# MEMORANDUM

<b>Date:</b> January 26, 2024	
<b>To:</b> Brian Froelich, Senior Planner	<b>Organization:</b> City of Capitola
<b>From:</b> RRM Design Group	<b>Title:</b> Design Review Team
<b>Project Name:</b> 38 <sup>th</sup> Avenue Apartments	<b>Project Number:</b> 1783-08-CU24
<b>Topic:</b> 1098 38 <sup>th</sup> Avenue Apartments Design Peer Review

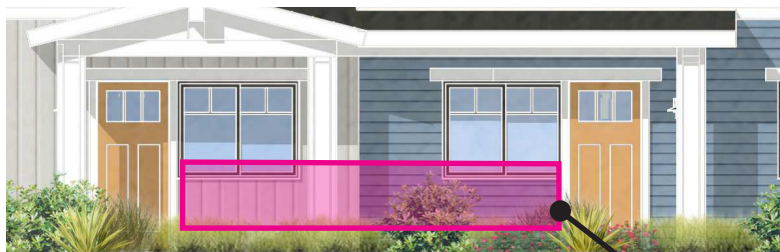
While the proposed refuse storage areas are appropriately screened from the public view by a solid enclosure, the applicant should reconsider the location of the western enclosure, as it is located near proposed open space. Moving the enclosure to the eastern parking lot will ensure unwanted odors are not impacting the front yard courtyard, assuming this works for trash company and client program.

Consider re-locating trash enclosure to eastern parking lot to avoid conflict with frontyard courtyard.

*Building A North Elevation*

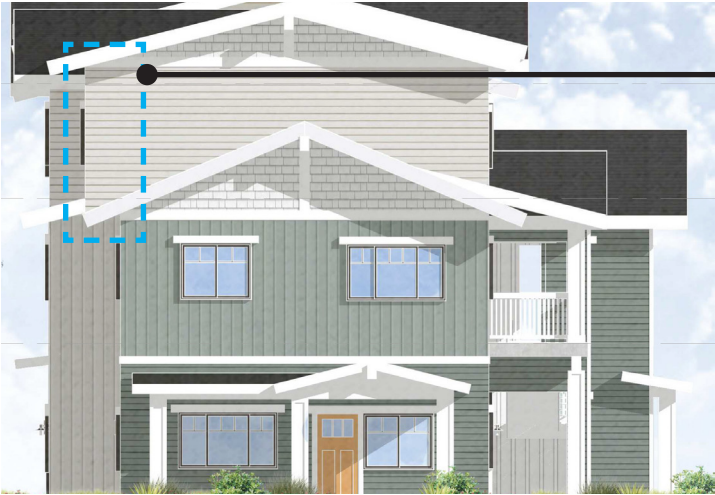
Articulation and detailing are important components to help provide richness and depth within a project design. In reviewing Building A, the applicant has appropriately proposed various articulation elements, such as bumping out sections of the building to provide enhanced visual interest and incorporating setbacks on the upper levels to break up large elevations (OS 17.82.080.A.2). However, in reviewing the North, East, and South Elevations, the applicant should consider adding additional articulation to create more interest at Building A and to break-up blank space to provide architectural integrity on all sides of the structure (OS 17.82.080.A.3).

Incorporate articulation/detailing on elevation to minimize blank space.

*Building B West Elevation*

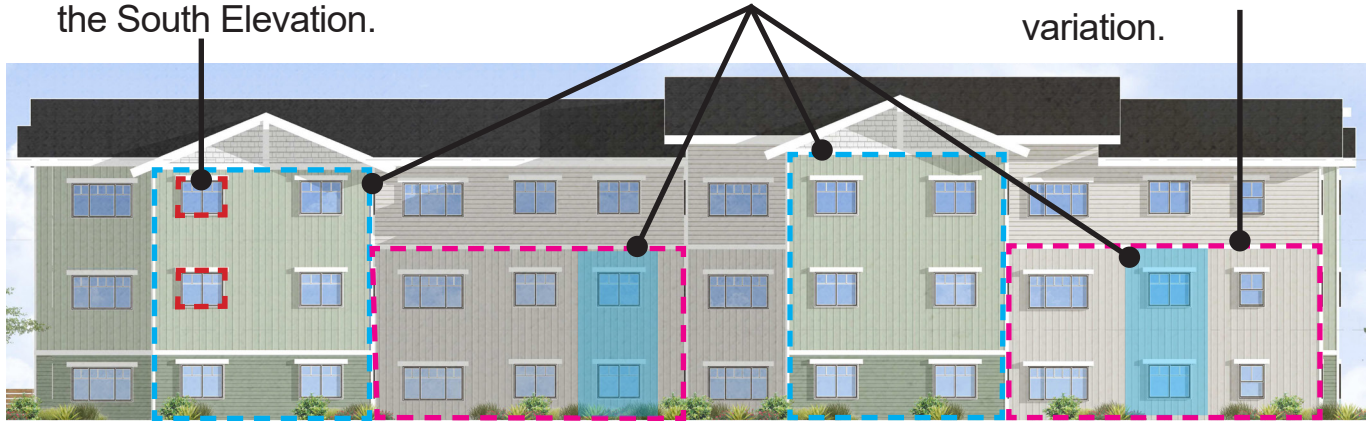
Articulation and detailing are important components to help provide richness and depth within a project design. In reviewing Building A, the applicant has appropriately proposed various articulation elements, such as bumping out sections of the building to provide enhanced visual interest and incorporating setbacks on the upper levels to break up large elevations (OS 17.82.080.A.2). However, in reviewing the North, East, and South Elevations, the applicant should consider adding additional articulation to create more interest at Building A and to break-up blank space to provide architectural integrity on all sides of the structure (OS 17.82.080.A.3).

Update this elevation as the third floor does not appear structurally sound.
